**LEVY NUCLEAR PLANT, UNITS 1 AND 2  
DOCKET NOS. 52-029 AND 52-030  
SUPPLEMENT TO PARTIAL RESPONSE TO NRC RAI LETTERS 116, 117 and 118 – SRP  
SECTIONS 6.3 AND 15.2.6**

**Duke Energy**  
**Enclosure 4**  
**Levy Nuclear Plant Units 1 and 2**  
**AP1000 DCD Tier 2 Licensing Basis Document -**  
**Proposed Changes**  
**(14 pages including cover page)**

**Enclosure 5  
Duke Energy  
Levy Nuclear Plant Units 1 and 2  
Part 2 and Part 4 COL Application Revisions  
(31 pages including cover page)**

Figure 6.3-201 (Sheet 3 of 3)  
 Passive Core Cooling System  
 Piping and Instrumentation Diagram  
 Rev. X

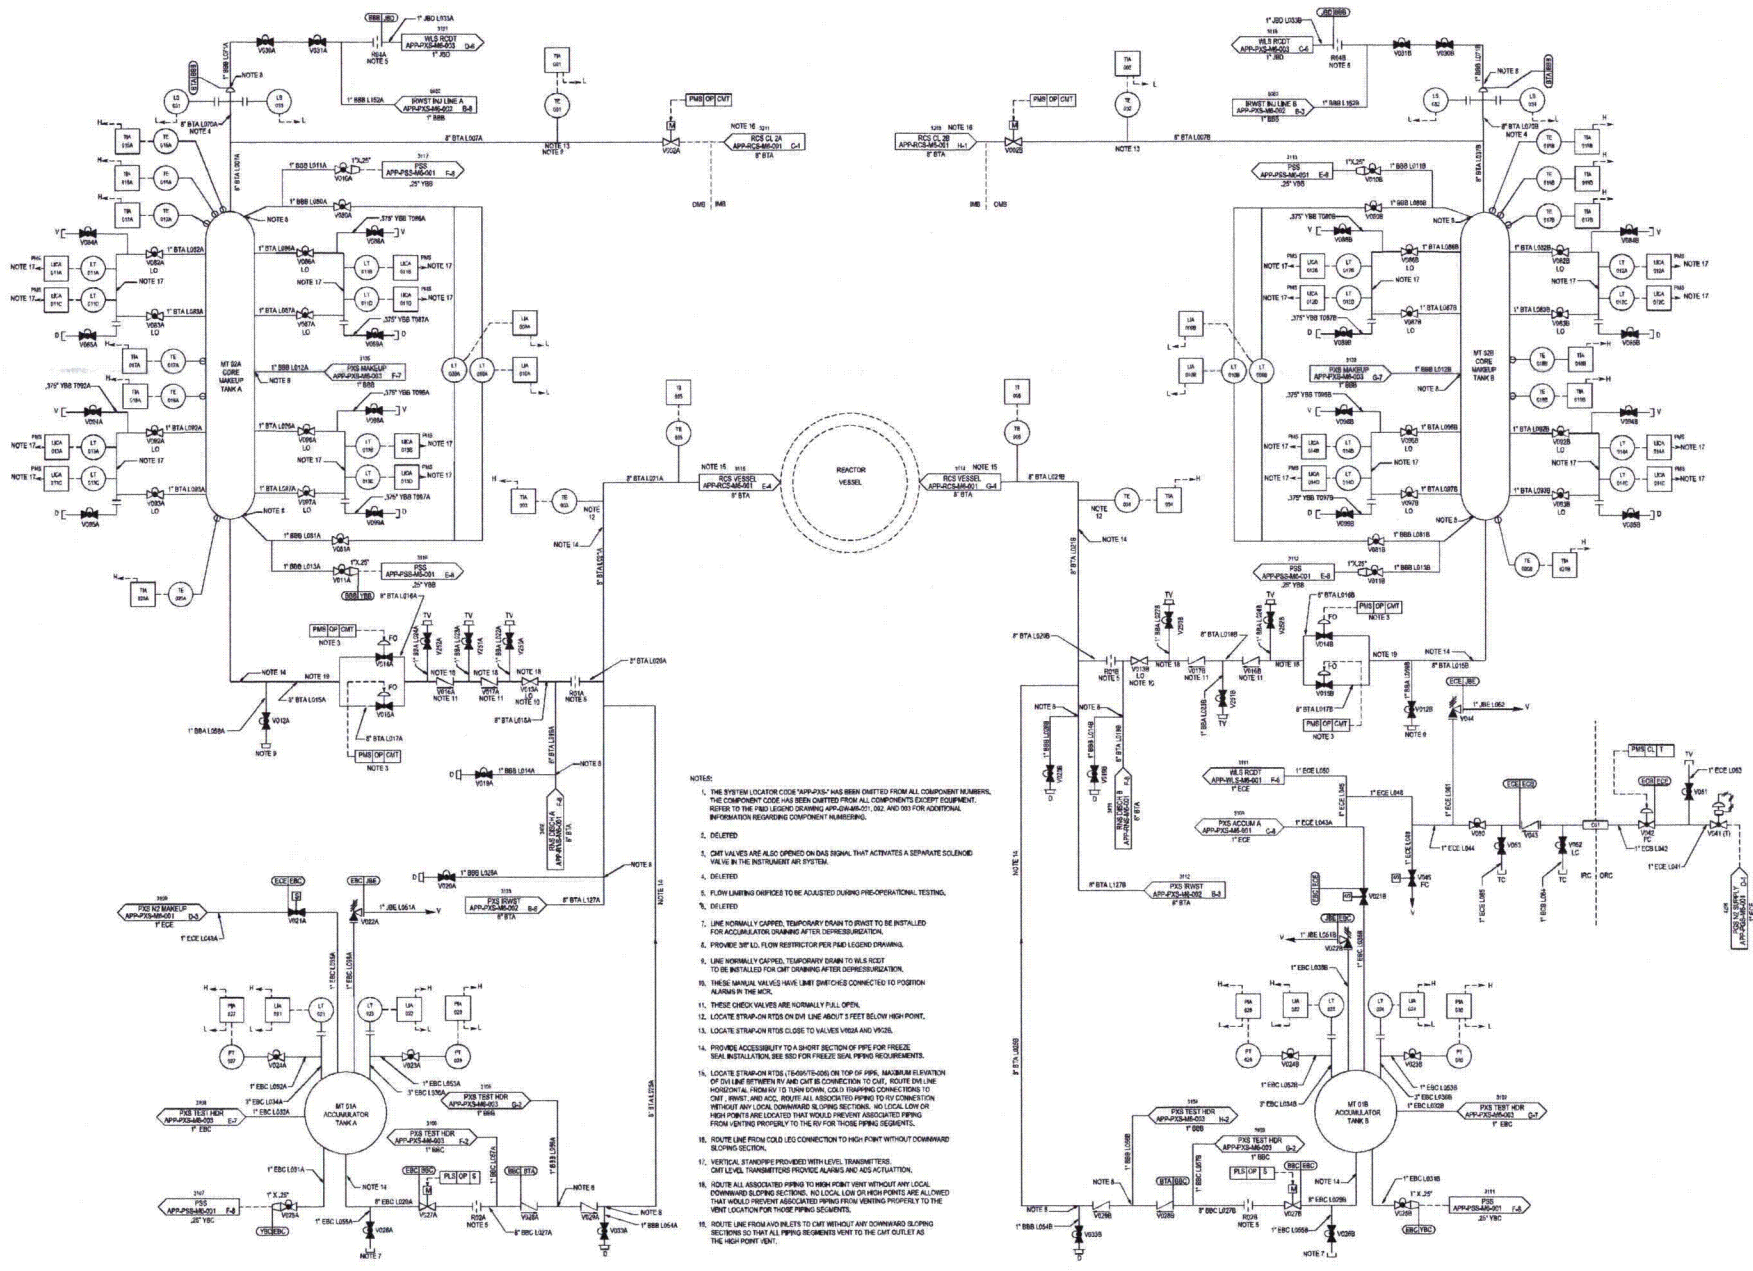
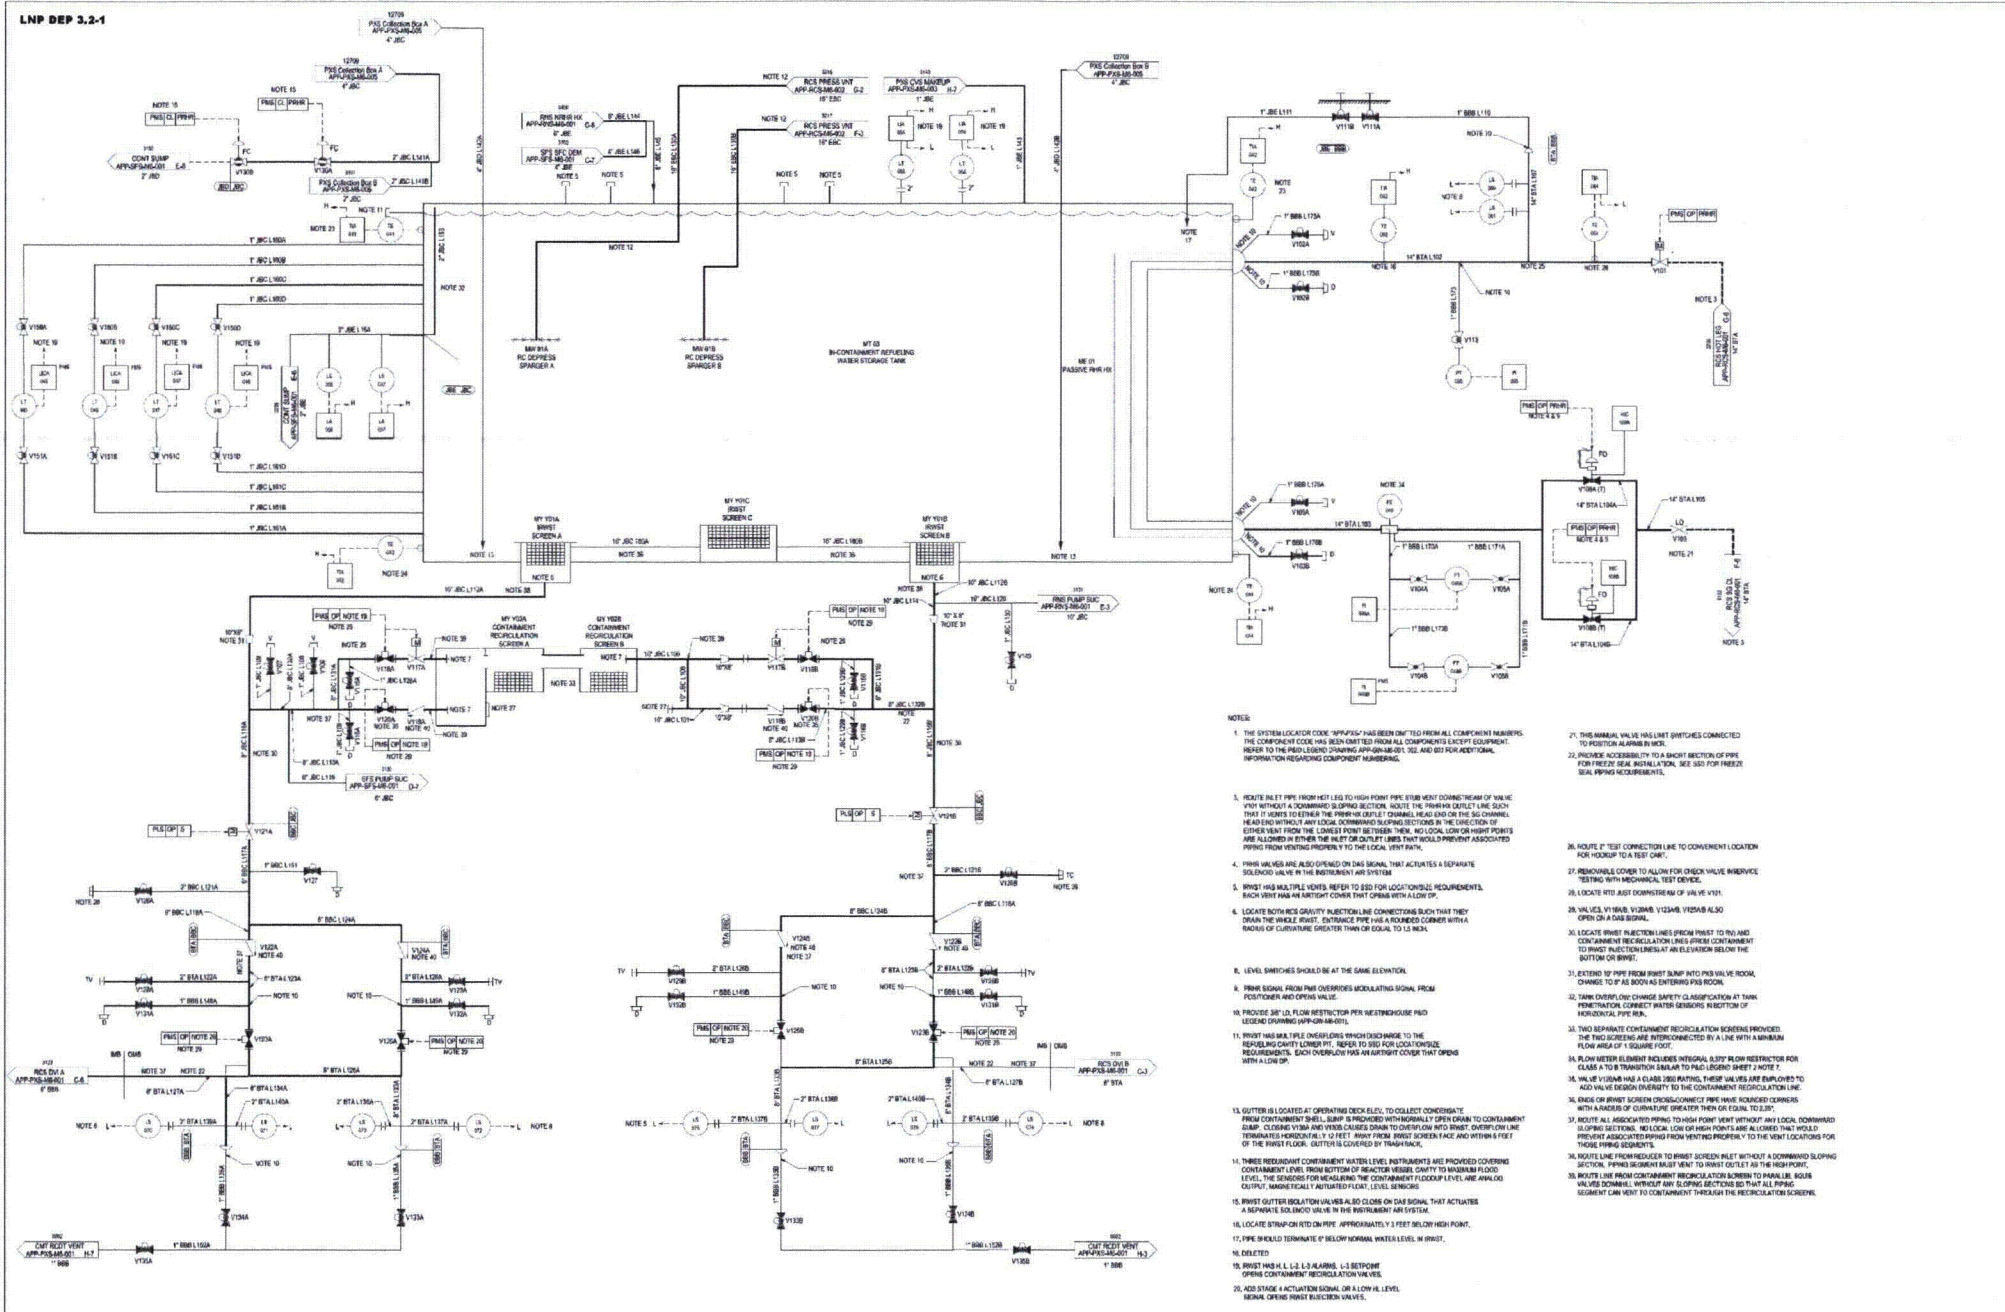
18. COLA Part 2, FSAR Section 6.3 will be revised to add a departure from DCD Figure 6.3-1 as Figure 6.3-201, as shown in Sheets 1 through 3 of Figure 6.3-201 in the attachment to this enclosure, with a LMA of LNP DEP 3.2-1. These sheets replace the figure added as Figure 6.3-201 in LNP COLA Revision 6.

Figure 19E.4.10-201  
**Shutdown Temperature Evaluation,**  
**RCS Temperature**

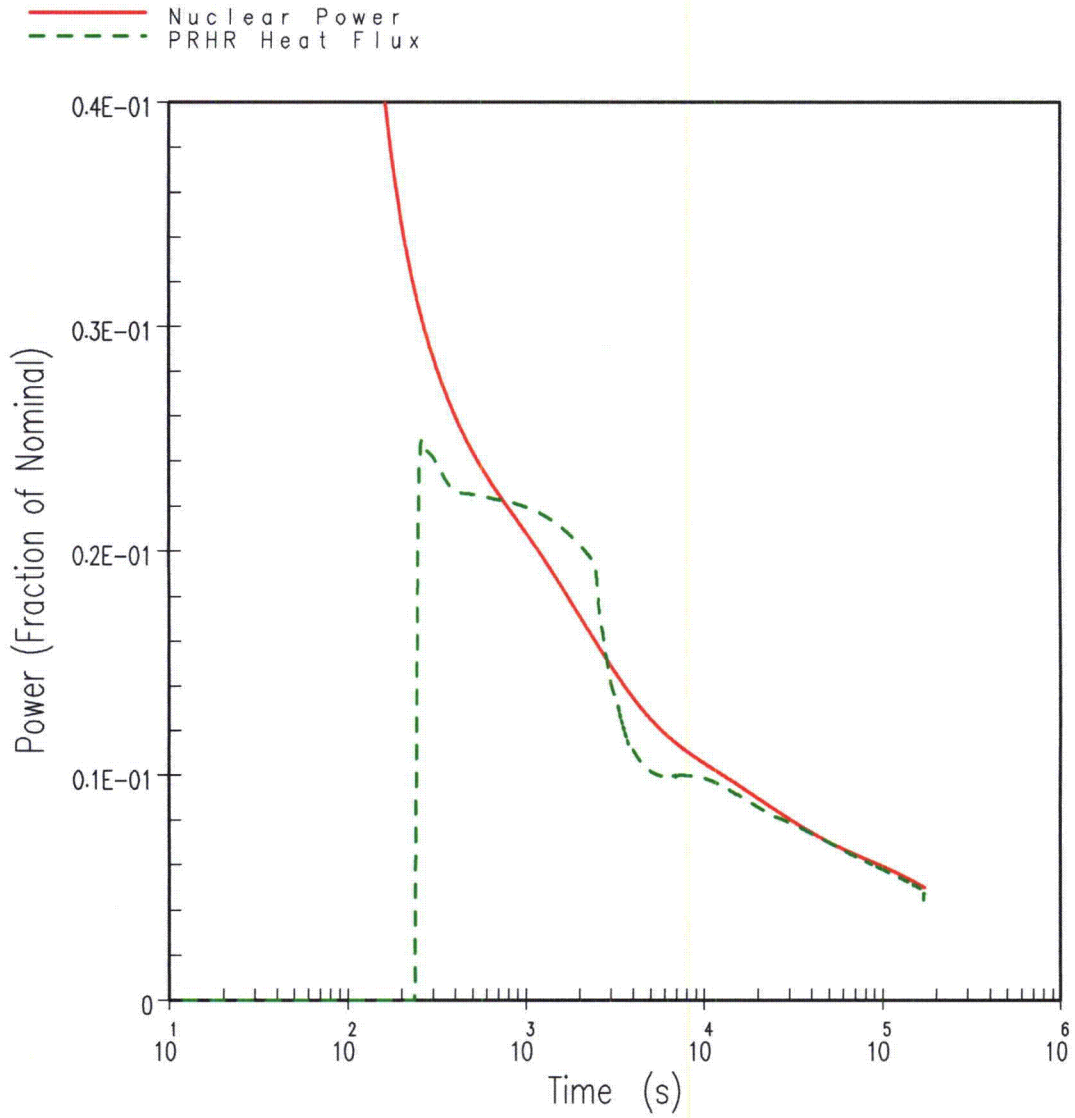
30. COLA Part 2, FSAR Section 19E will be revised to add a departure from DCD Figures 19E.4.10-1 through 19E.4.10-4 as Figures 19E.4.10-201 through 19E.4.10-204, with a LMA of LNP DEP 3.2-1. These figures shall also be added to the list of figures for Chapter 19. Figures 19E.4.10-201 through 19E.4.10-204 are shown in the attachment to this enclosure.
